Appl. No.: 10/709,679
Amdt. Dated: 7/6/2005
Reply to Office action of: 05/09/2005

AMENDMENTSTOTHEDRAWINGS:

REMARKS/ARGUMENTS

Fig. 3

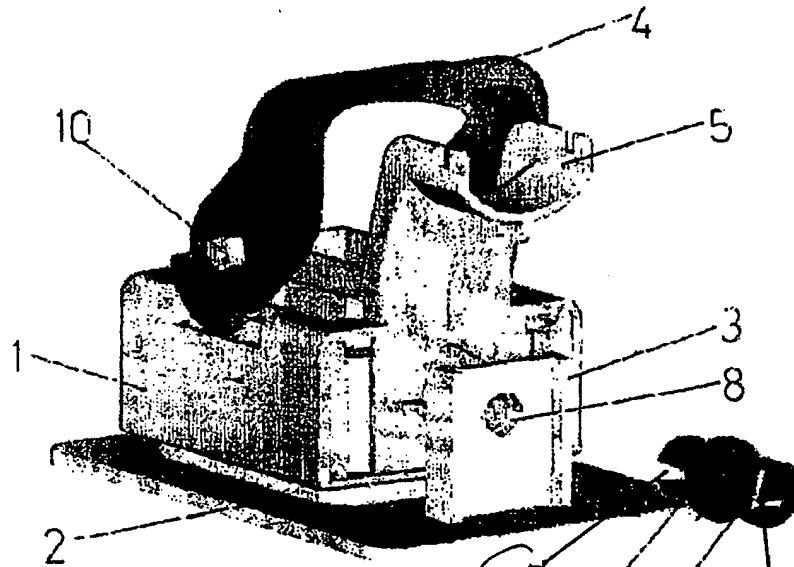
Amended Figures 3 and 4 label the non-universal screw head slot and the sidewall opening in the trunco-conical part.

Element 17 Added

The attached sheet(s) of drawings includes amended Figures 3 and 4 having two omitted numbers added to identify clearly two of the elements shown therein, and new Figures 5 and 6.

Fig. 4

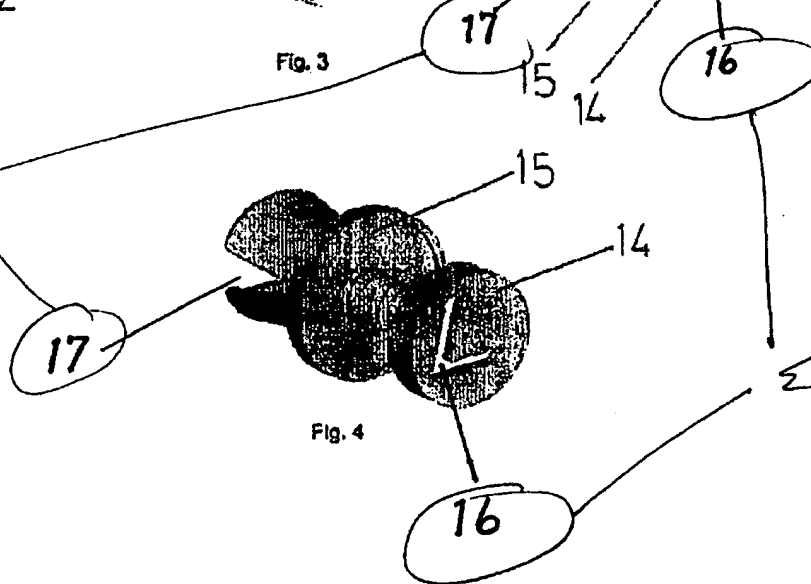
Therefore, the screw with a hollow trunco-conical part partially introduced therein and a non-universal configuration must be shown or the feature(s) canceled from the claims 1 – 2. No new matter should be entered.

... because they fail to show the screw provided with a partially introduced hollow-conical part, its open ends and the side opening in the wall as well as a particular head as described in the specification.

Evidence that claims fail to correspond in scope with that which applicant(s) regard a the invention can be found in the Figure 4 which shows a screw 14 partially introduce in a trunco-conical part (not numbered). This indicates that the invention is different from what is defined in the claim(s) because the claim suggests the part 15 is partially introduced in the screw.

Note: A screw 14 with a universal head and partially introduced in a trunco-conical part (not numbered) has been assumed.

Applicant has amended original Figure 4 to identify the non-universal screw head slot (17) inadvertently not labeled, and has amended the specification to more clearly

describe this non-universal screw head slot (17) shown in original Figure 4. In addition, the specification has been amended to describe more clearly the mounting of screw (14) in anchor body (15) as also originally shown in original Figure 4. The confusion in the description of mounting the screw (14) in the anchor body (15), pointed out by the Examiner having arisen from an error in translation. Therefore, Applicant believes that this objection has now been rendered moot and requests that it be removed.

Element 16 added
